Monticello Nuclear Generating Plant
Revision No. 2 License Amendment Request Dated September 7, 1976

Proposed Changes to the
Technical Specification Pages

Exhibit B consists of revised pages for the Monticello Nuclear
Generating Plant Technical Specifications as listed below:

Figure 3.5.1 Single Loop Operation Surveillance Power/Flow Curve

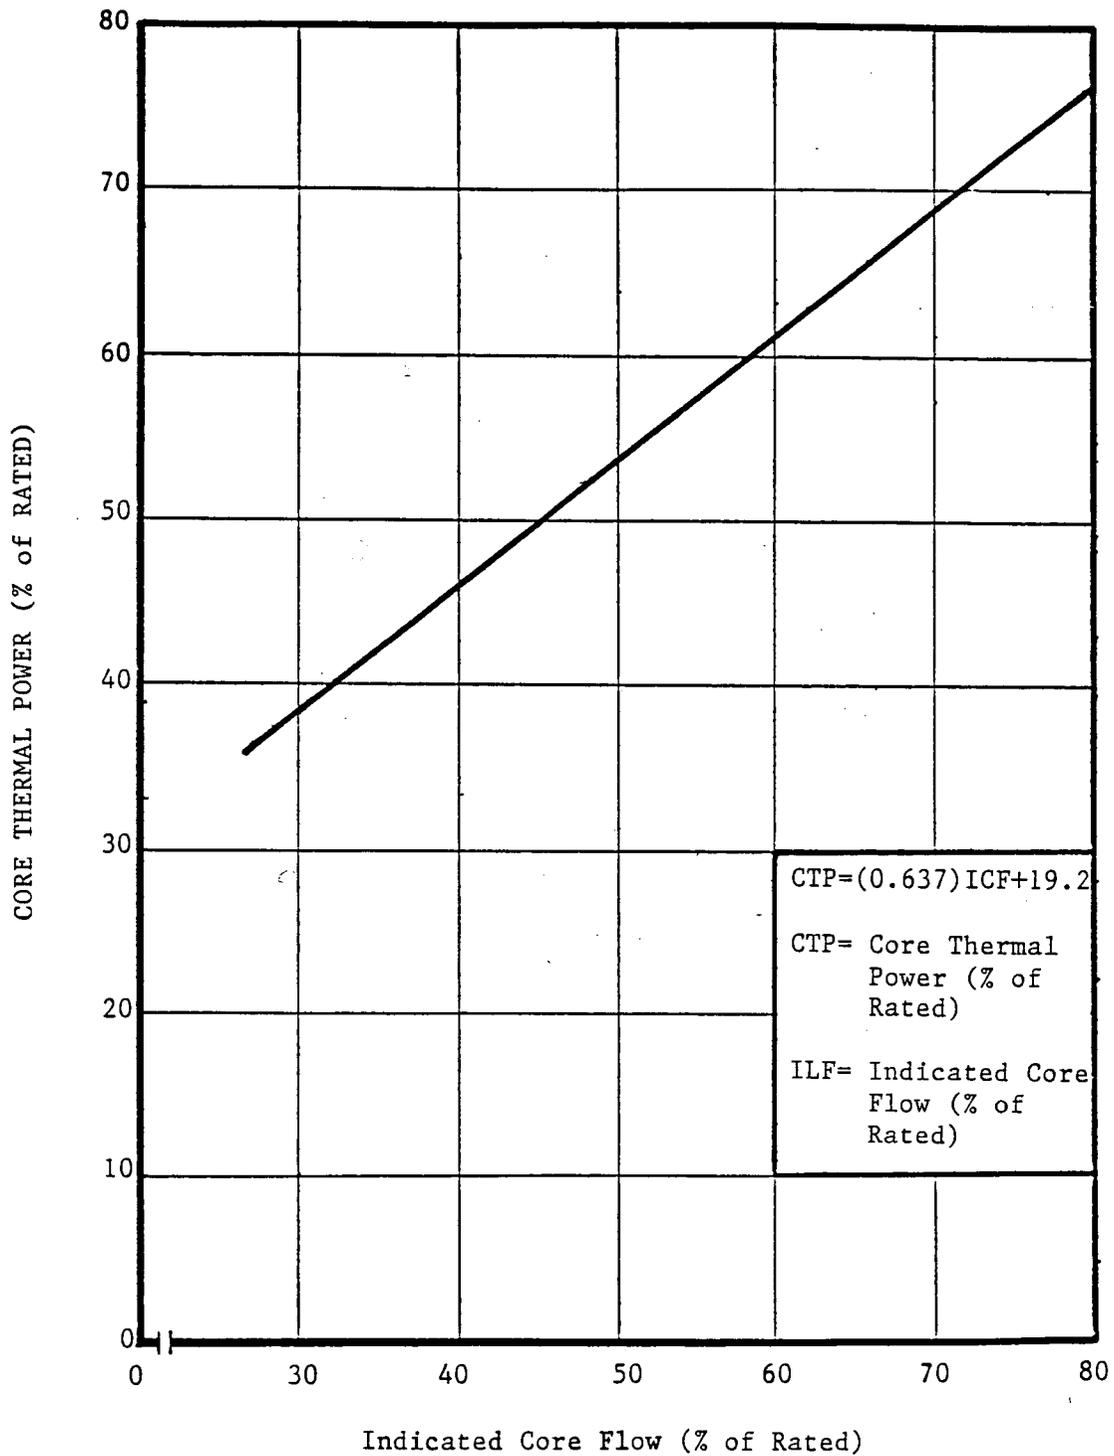
3. The APRM Neutron Flux Scram and APRM Rod Block setpoints will be changed as noted in Specification 2.3.A and Table 3.2.3.
 - b. Total core flow will be maintained greater than 39% when core thermal power is above the limit specified in Figure 3.5.1.

2. action shall be taken to:
 - b. reduce total core flow to less than 45% and,
 - b. reduce core thermal power to less than the limit specified in Figure 3.5.1.

1. See Specification 4.6.G
2. The following baseline noise levels will be obtained prior to operation with only one recirculation pump in operation at a core thermal power greater than that specified in Figure 3.5.1 or with a core flow greater than 45% provided that baseline values have not been established since the last core refueling. Baseline values will be taken with only one recirculation pump running.

- a. Establish a baseline core plate ΔP noise level.
 - b. Establish a baseline APRM and LPRM neutron flux noise level.
3. With only one recirculation loop in operation at a core thermal power greater than that specified in Figure 3.5.1 or with a core flow greater than 45%, determine the following noise levels at least once per 8 hour period and within 30 minutes after a core thermal power increase of greater than 5% of rated thermal power.
